LAND USE PETITION IN THE BOWIE PLANNING AREA

Revision to Specific Design Plan #SDP-0313

**SUBJECT: Revision to Specific Design Plan #SDP-0313
Citibank at Bowie Corporate Center
MD Route 197
Bowie Town Center**

Subject: Revision to Specific Design Plan #SDP-0313
Citibank at Bowie Corporate Center

SOUTH ELEVATION
 (Facing MD Rt 197)

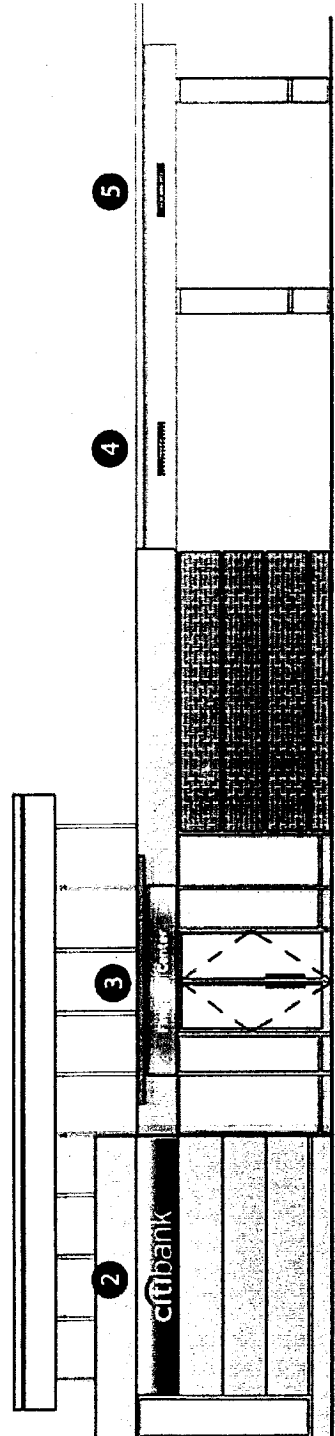
COMMENT: According to the architectural elevations and plans for signage submitted, Citibank proposes two (2) types of signs: building-mounted signs and directional signs. Two (2) of the building-mounted signs are primary identification signs and include the bank's name. One building-mounted identification sign (37.5 sq. ft. in area) is proposed on the front (southern) elevation (Attachment 5A), while the second building-mounted identification sign (62.5 sq. ft. in area) is proposed on the side (western) elevation (Attachment 5B). A third building-mounted sign (20.6 sq. ft. in area) is proposed above the customer entrance, is incidental in nature, does not advertise the bank and indicates the use as a "Financial Center" (Attachment 5A). The total area of these three (3) building-mounted signs is 120.6 sq. ft.

mounted signage totaling 106 sq. ft. would be permitted; the area of all building-mounted signage on the subject bank is 125.7 sq. ft. (For comparison purposes, the total area of approved building-mounted signage on the Wachovia Bank was 132 sq. ft.) Therefore, the total area of the six (6) building-mounted signs proposed on the Citibank building is comparable to the existing other bank and is acceptable.

- A. A maximum of two (2) primary identification, building-mounted signs shall be permitted. One (1) building-mounted identification shall be located on the front (southern) elevation and shall not exceed 37.5 sq. ft. in area. The second building-mounted identification sign shall be located on the side (western) elevation and shall not exceed 62.5 sq. ft. in area. A third building-mounted sign, located above the customer entrance to the bank, reading "Financial Center", shall be permitted and shall not exceed 20.6 sq. ft. in area.

SIGN INVENTORY

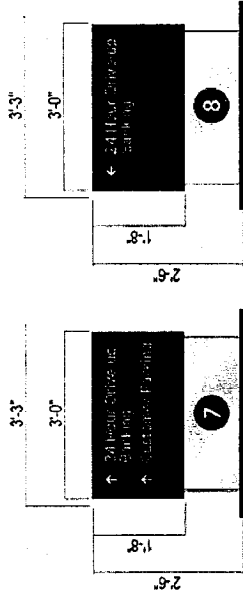
Four (4) directional signs are proposed by Citibank. Each directional sign is 2.5 ft. high on a solid base (Attachment 5D). The area of each directional sign is 5 sq. ft. Due to the potential of the directional sign proposed in the southwestern area of the parking lot (Sign #8, Attachment 5E) to be blocked by parked vehicles, it is recommended that this sign be deleted. To offset the elimination of this sign, the directional arrow on Sign #7, informing customers of the location of the drive-through area, should be revised. Likewise, directional Sign #9, proposed in the southeastern portion of the parking lot, also has the potential to be obscured by parked vehicles. Therefore, to eliminate this potential, it is recommended that Sign #9 be relocated to the southeastern area of the drive-through aisles, along the southeastern property line of the site. These recommended changes result in a maximum of three (3) directional signs, each with a height of 2.5 ft. and an area of 5 sq. ft.

- C. A maximum of three (3) directional signs shall be permitted for this use/building. The total height of each directional sign and base shall be reduced to not more than 2.5 feet. The area of each directional sign shall not exceed 5 sq. ft. The arrow on directional Sign #7 shall be revised to indicate the location of the drive-through area to bank customers. Sign #8 shall be eliminated from the project. Sign #9 shall be relocated to the southeastern area of the drive-through aisles, along the southeastern property line of the site.

EXTERIOR ELEVATIONS

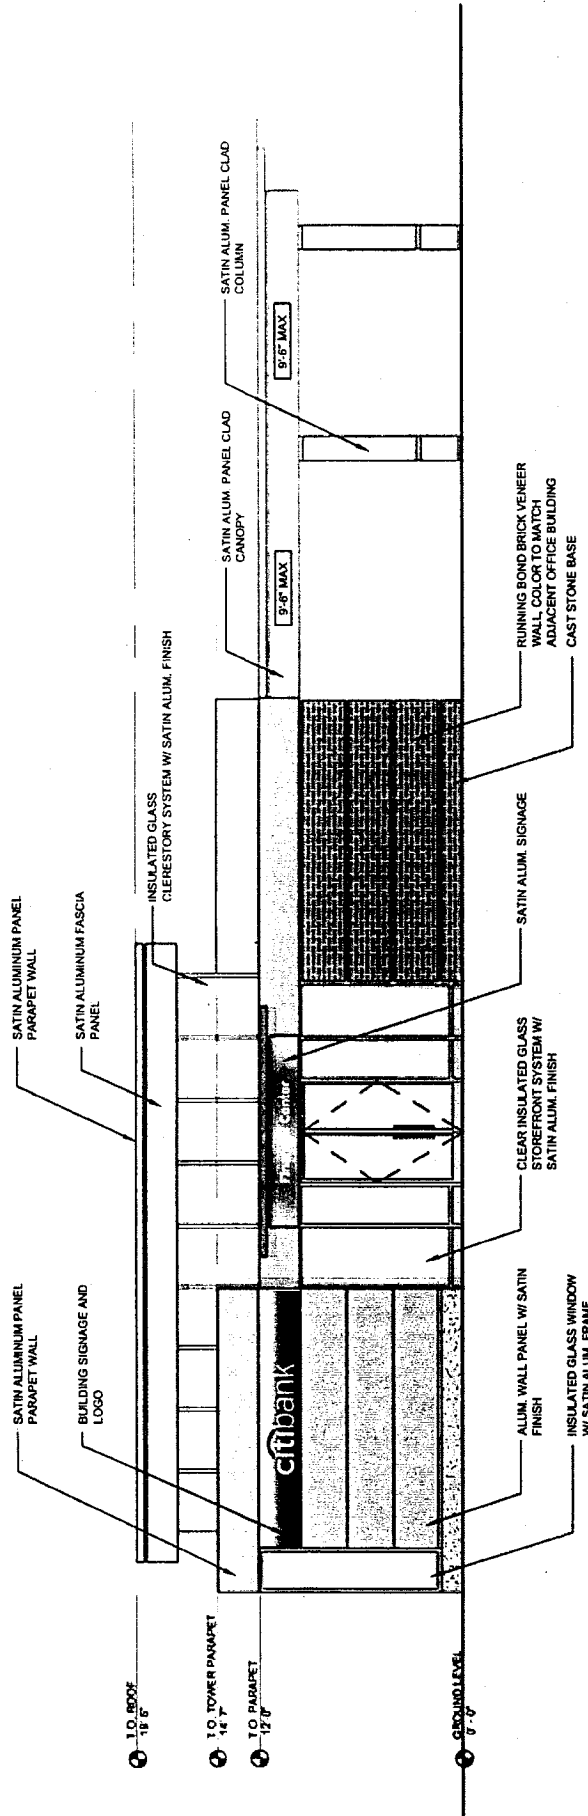
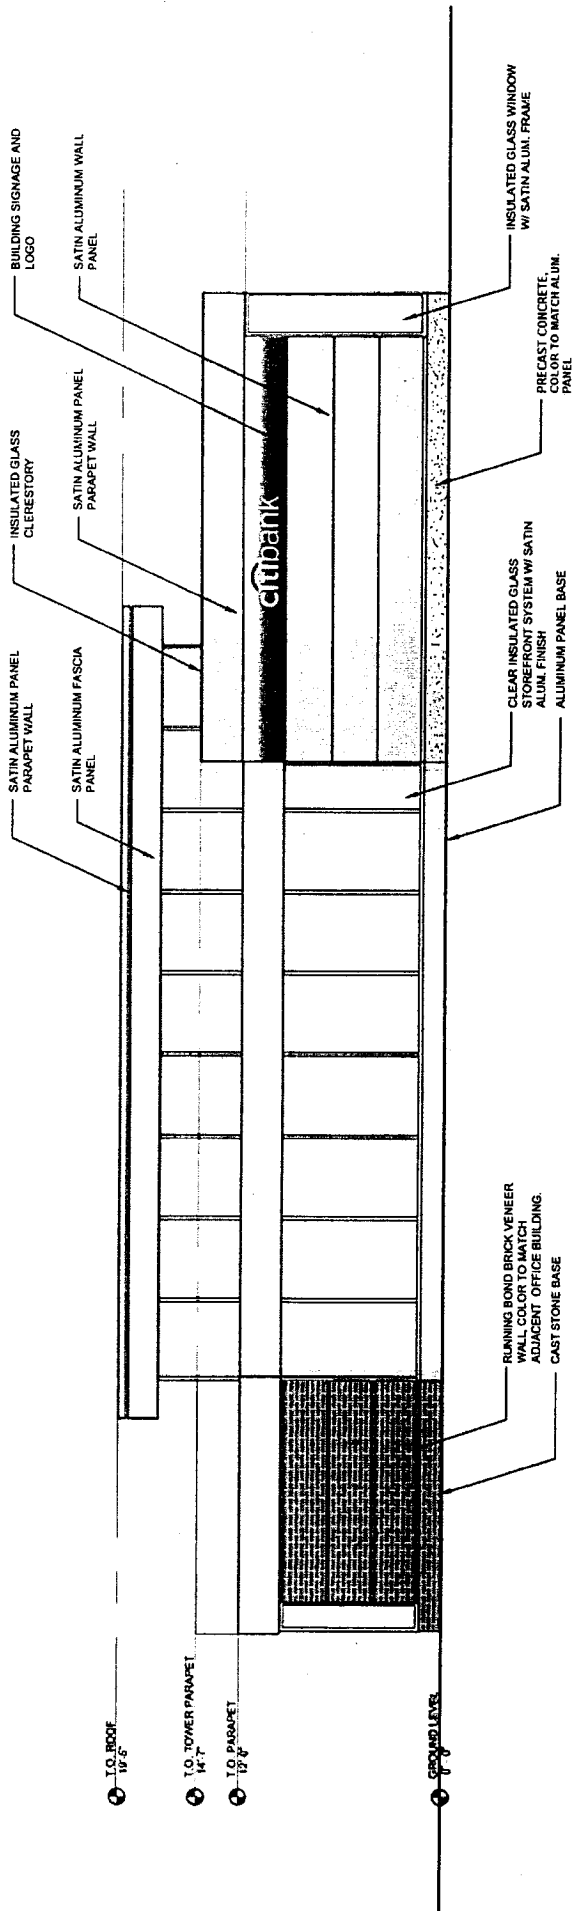
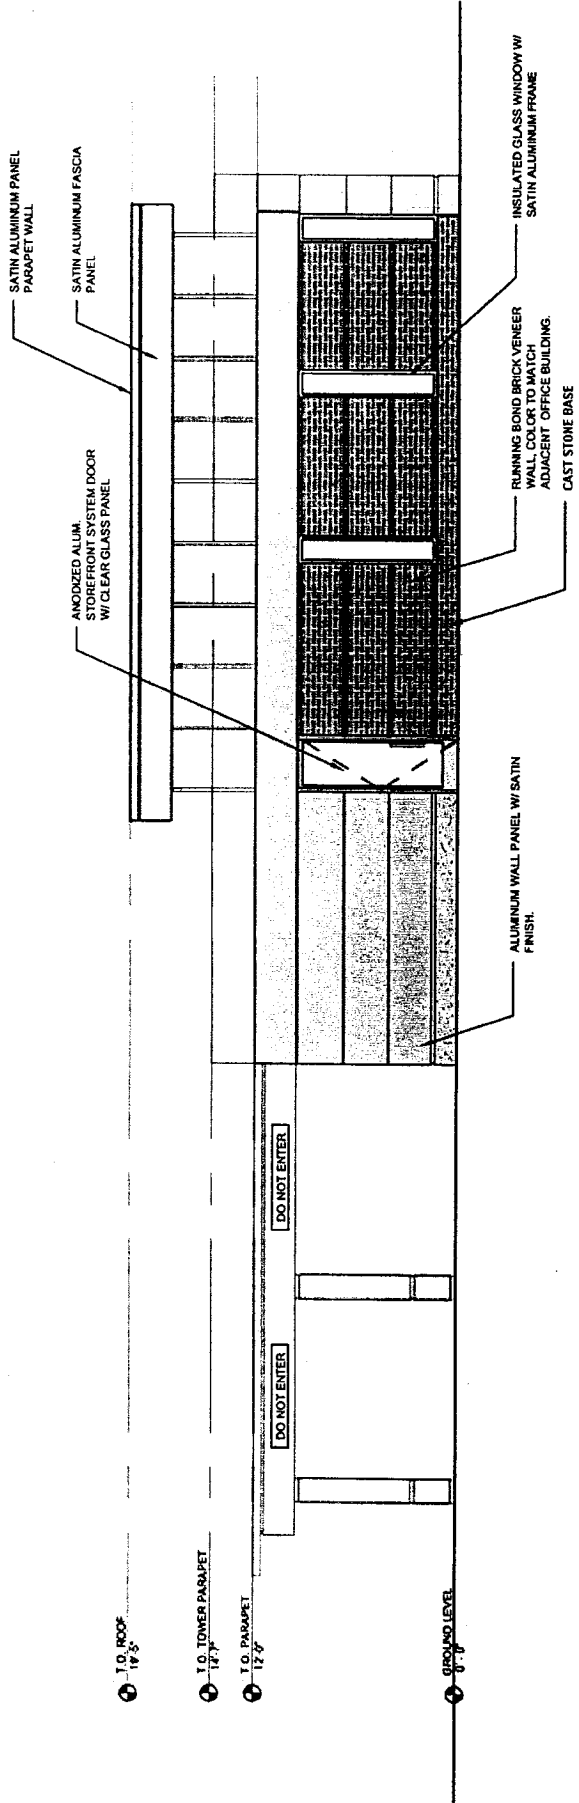
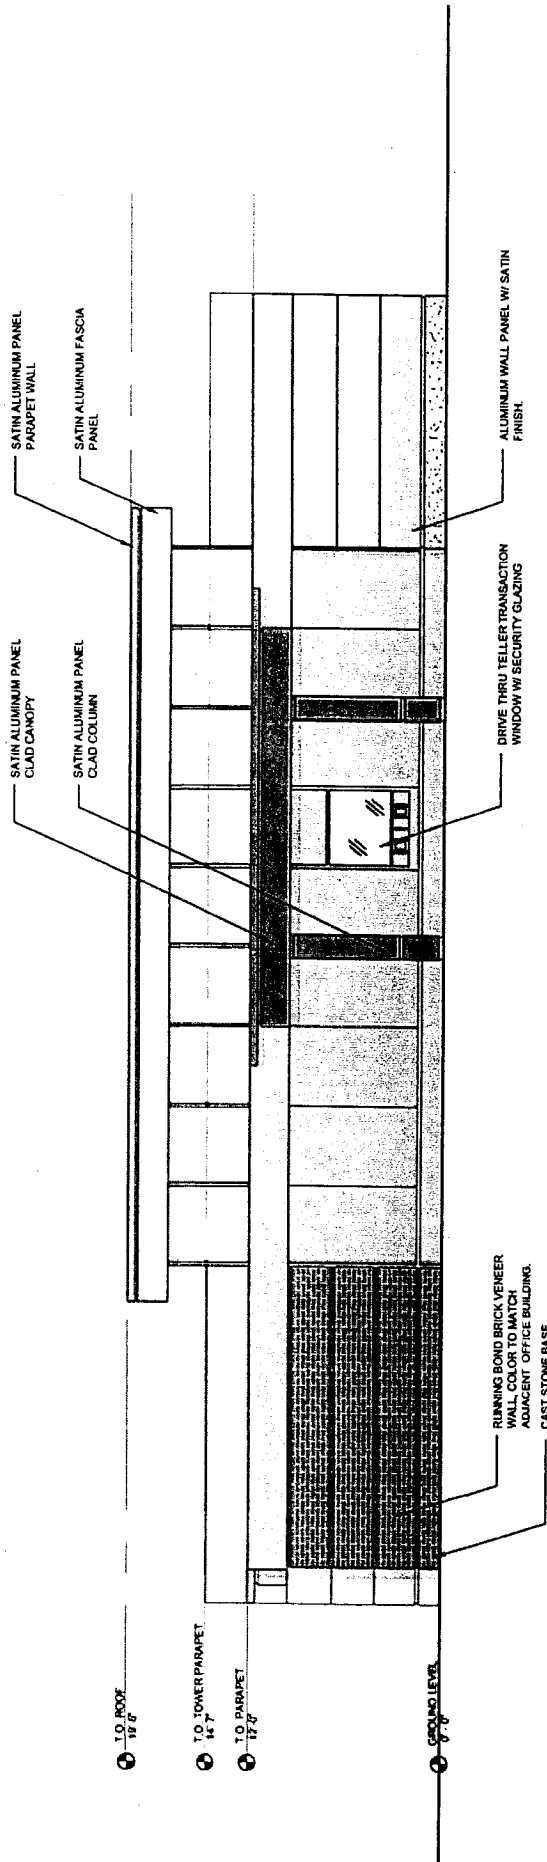
COMMENT: To ensure compatibility between the proposed building and the approved office and Wachovia bank buildings and to address the concerns of the ARC, the following features should be used on the Citibank building, and the plans should be revised accordingly:

1. The brick used on the Citibank building should be the same as that used on the multi-story office and Wachovia Bank buildings.
2. A screen wall should be provided and designed to conceal the HVAC units from ground level view.

3. The material and color of the HVAC screen wall should include the use of aluminum panels with a satin finish.

- A. The brick used on the Citibank building shall be the same as that used on the multi-story office and Wachovia Bank buildings.
- B. A screen wall shall be provided and designed to conceal the HVAC units from ground level view.
- C. The material and color of the HVAC screen wall shall include the use of aluminum panels with a satin finish.
